PROPOSAL REQUEST

JLG 18126 Eastgate Apartments

Issued: December 22, 2020

PROPOSAL REQUEST #: 03

1 THIRD FLOOR - HVAC PLAN
0 4' 8' 16'

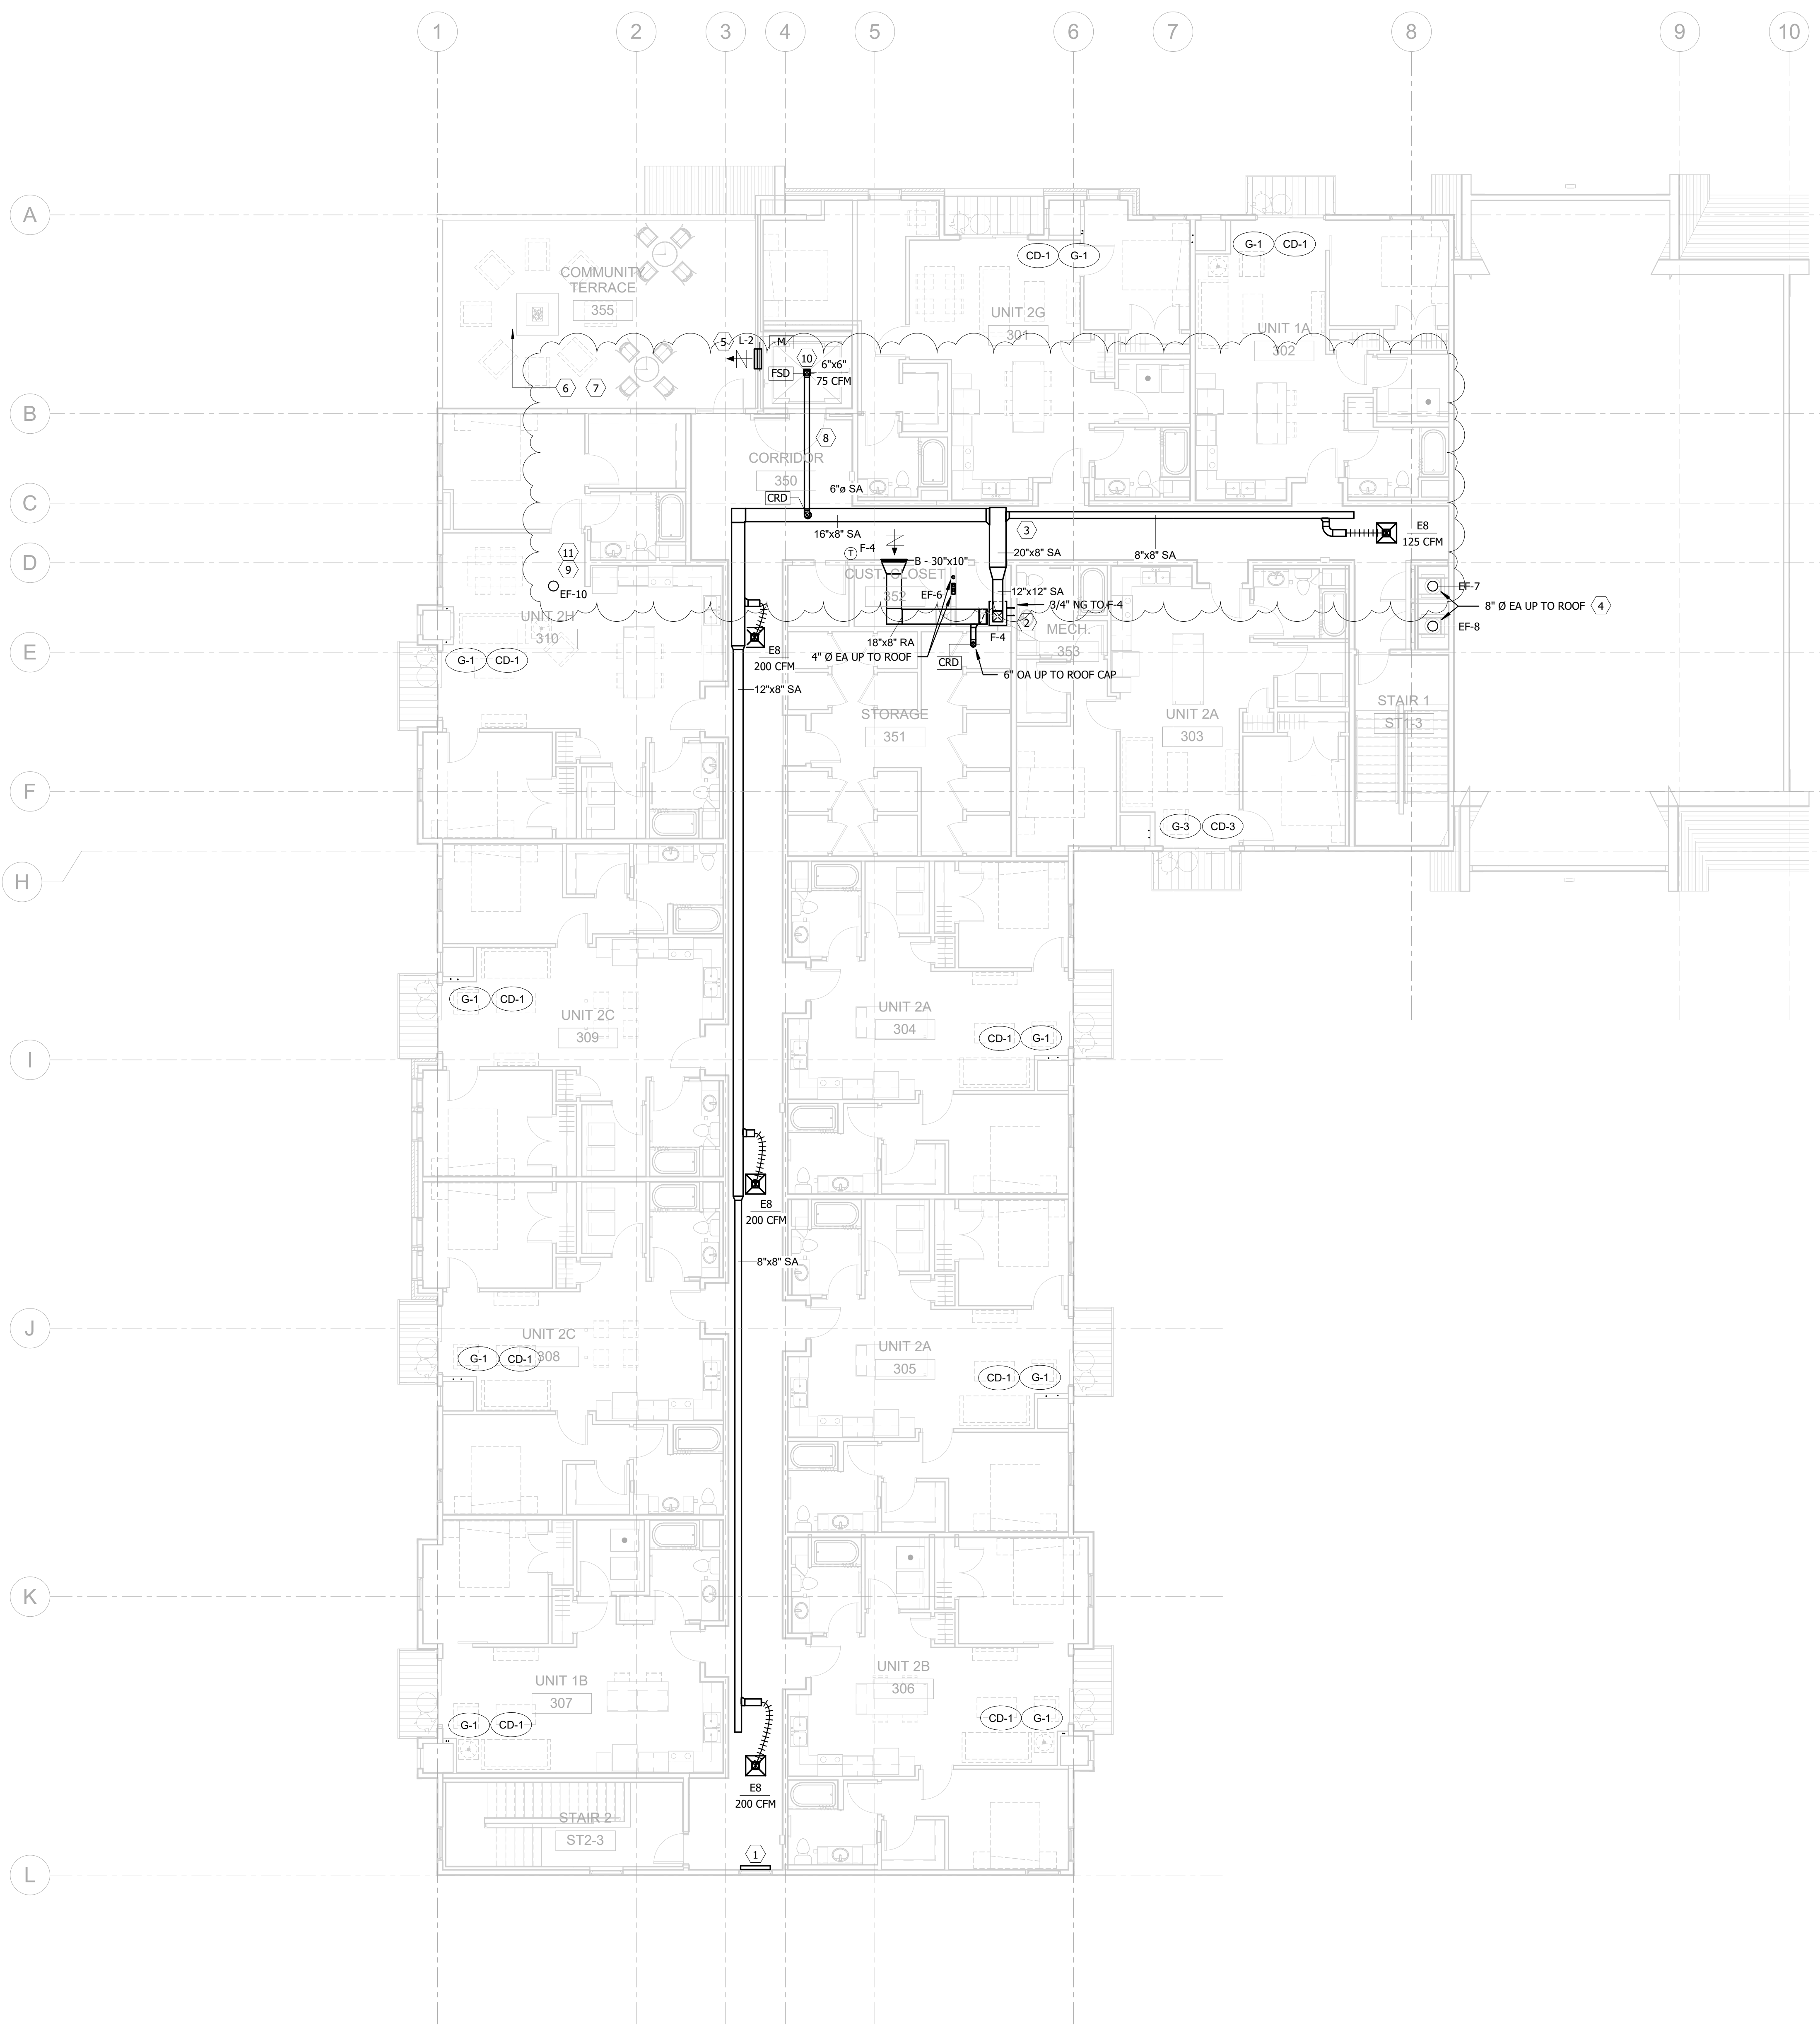
- c) Added keynote 10.
- Item No 04: Drawing M303 – Third Floor HVAC Plan
 - a) Added supply air to elevator hoistway.
 - b) Revised F-4 air distribution.

- c) Added keynote 9, 10, and 11.
- Item No 05: Drawing M801 – Mechanical Schedules
 - a) Revised exhaust fan schedule.
- Item No 06: Drawing E3.01- Ground Floor Electrical Plan:

- ROUTE SUPPLY AIR DUCT THROUGH ATTIC TO 6"x6" SUPPLY DIFFUSER INSTALLED AT TOP OF ELEVATOR HOISTWAY. PROVIDE CEILING RADIATION DAMPER AT DUCT PENETRATION INTO ATTIC AND INSULATE DUCT IN ATTIC PER CODE.

- CONNECT EF-10 TO 4" PVC RADON VENT PIPE IN ATTIC. SEE PLUMBING PLANS FOR EXACT LOCATION AND ADDITIONAL INFORMATION. COORDINATE WITH DIVISION 22.
- SUPPLY AIR TO ELEVATOR HOISTWAY SHALL PROVIDE POSITIVE PRESSURIZATION PER MPCA VAPOR MITIGATION BEST PRACTICES.

- FAN SPEED AND AIRFLOW SETPOINT SHALL BE MANUALLY ADJUSTED AS REQUIRED TO MEET ACTIVE RADON MITIGATION SYSTEM REQUIREMENTS.

1 THIRD FLOOR - PLUMBING PLAN
0 4' 8' 16'

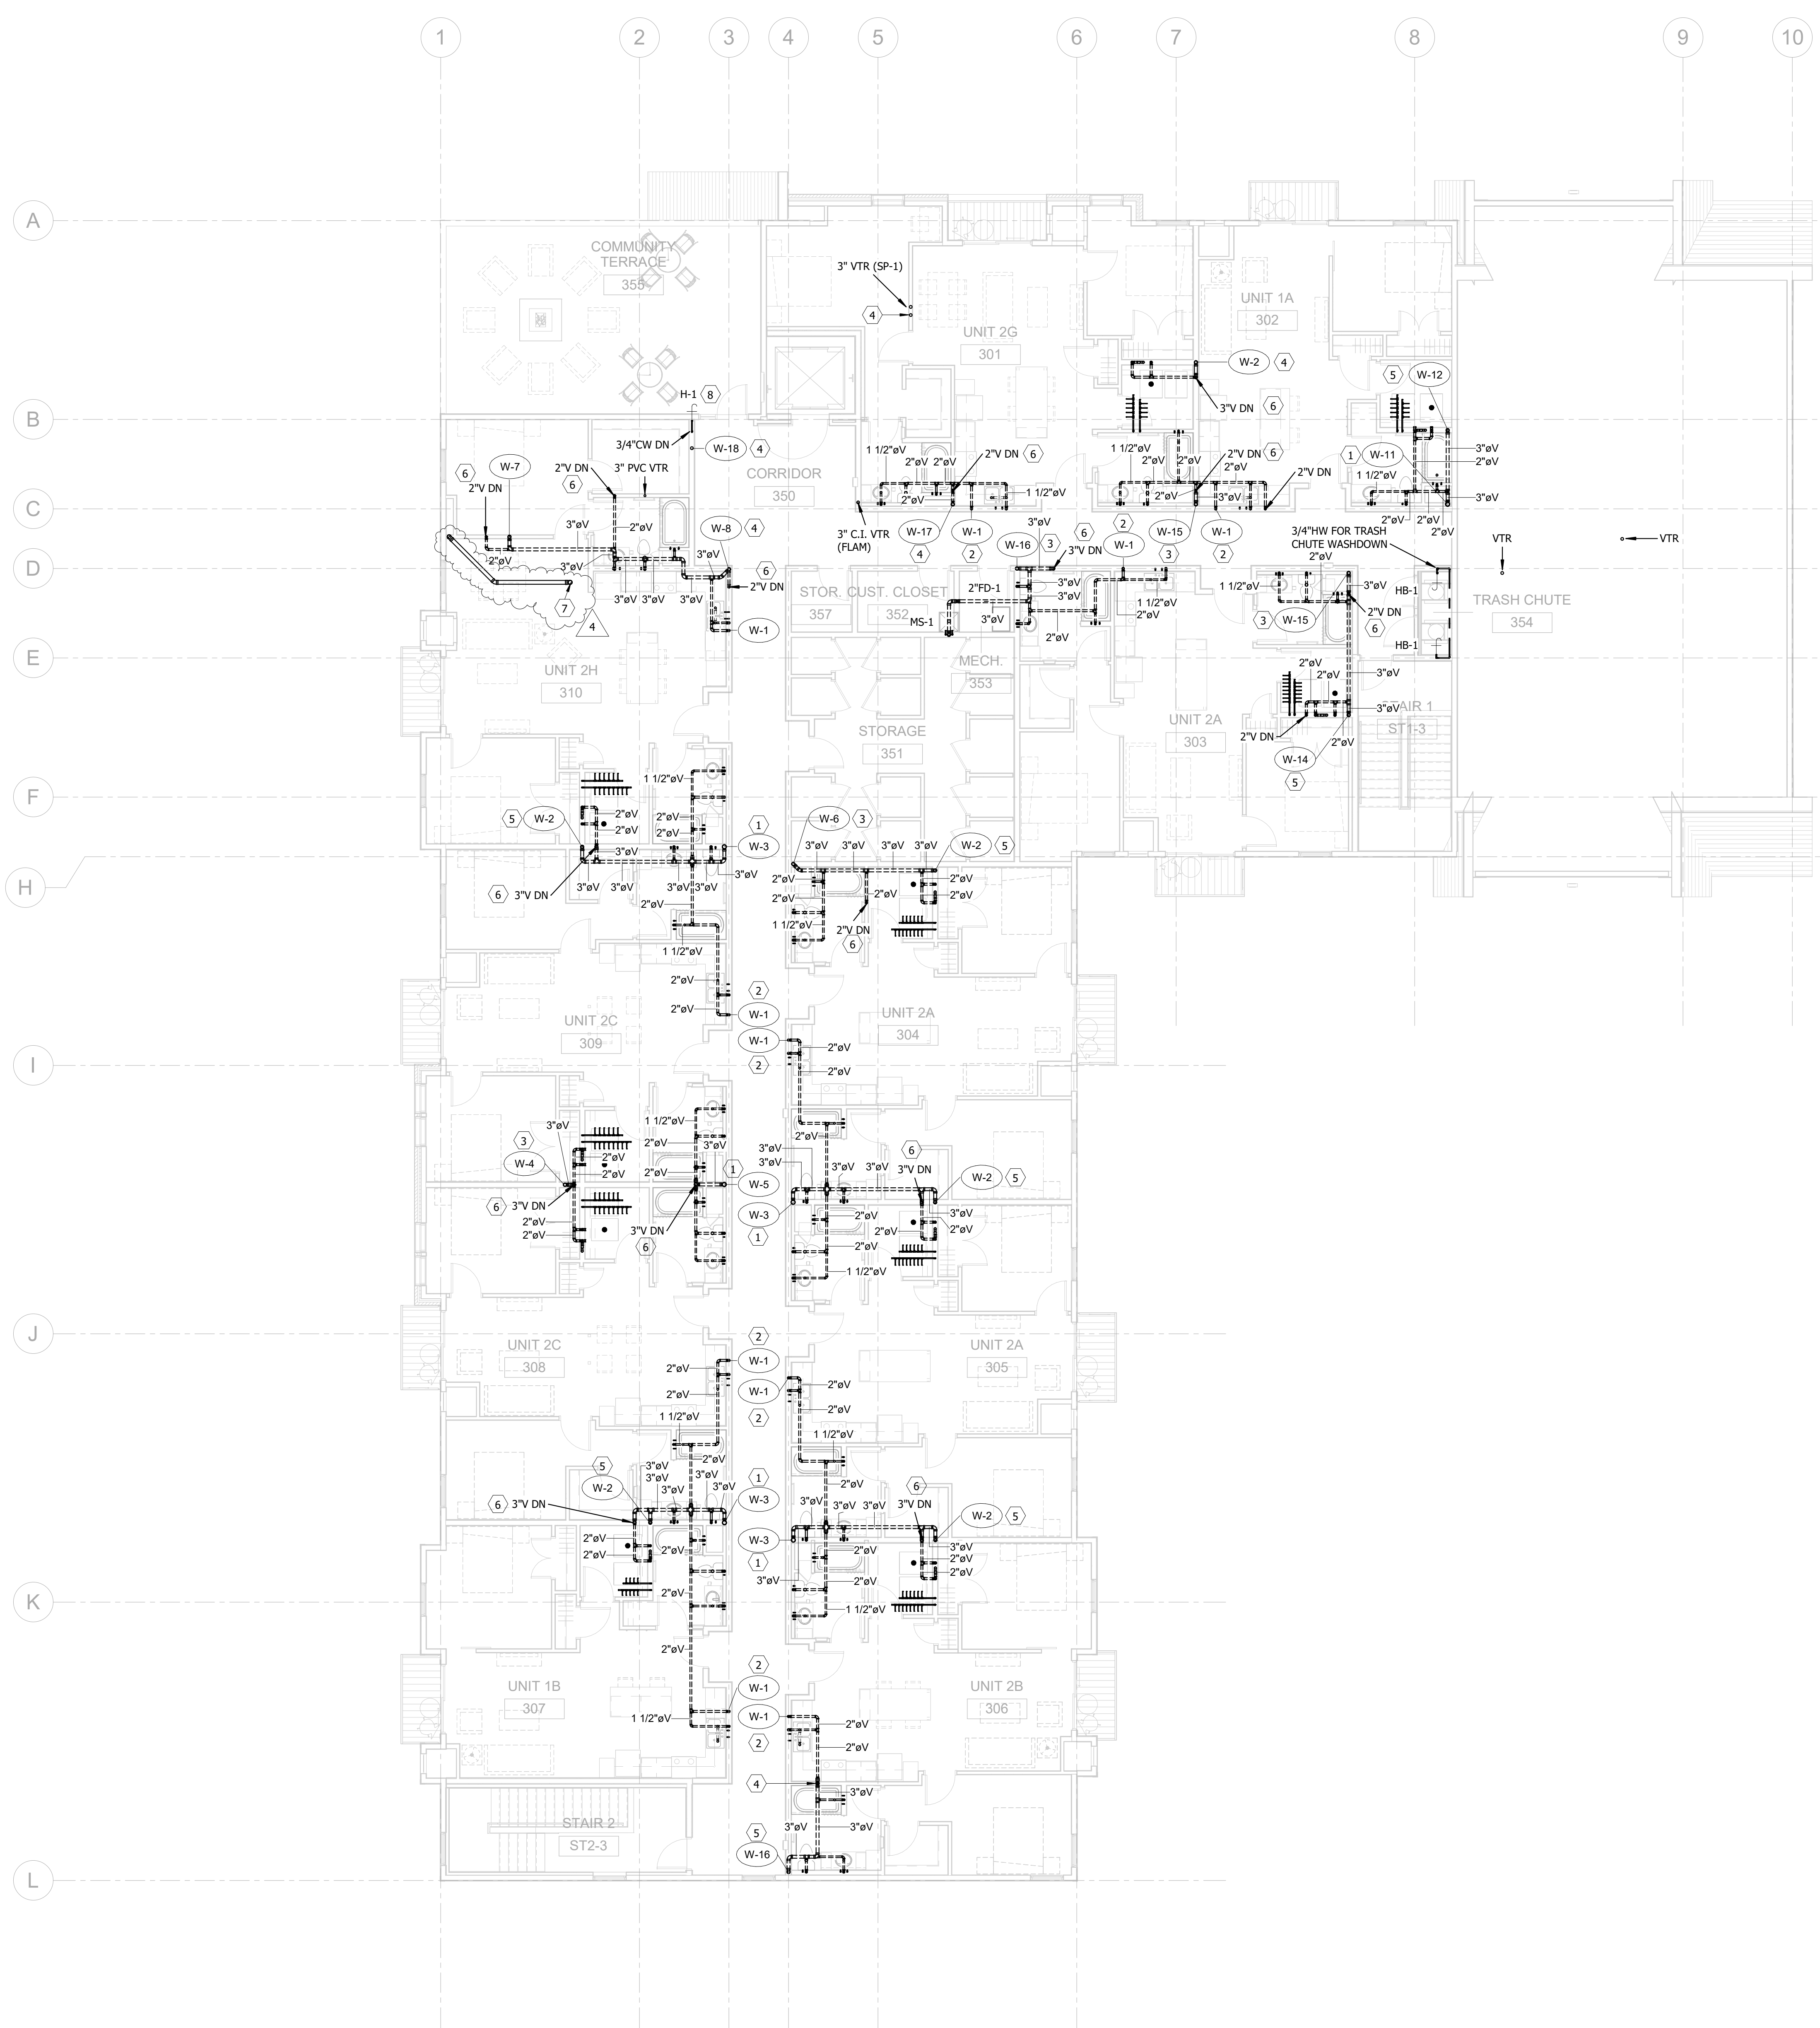
- a) Motor and Equipment Schedule: Added Exhaust Fans EF-9 and EF-10.
- Item No 09: Drawing E9.02 – Electrical Schedules:
- a) Panel HP-0-1: Added Exhaust Fan EF-9.
 - b) Panel HP-2-1: Added Radon Exhaust Fan EF-10.
- Item No 10: Drawing P001 – Plumbing Symbols and Legend
- a) Added general note OO.
- Item No 11: Drawing P203 – Third Floor Plumbing Plan:
- a) Revised 4" PVC radon vent to include offset in attic so that roof vent termination is at least 10 FT from window openings below.
 - b) Added verbiage to Keynote #7 as shown on drawing.
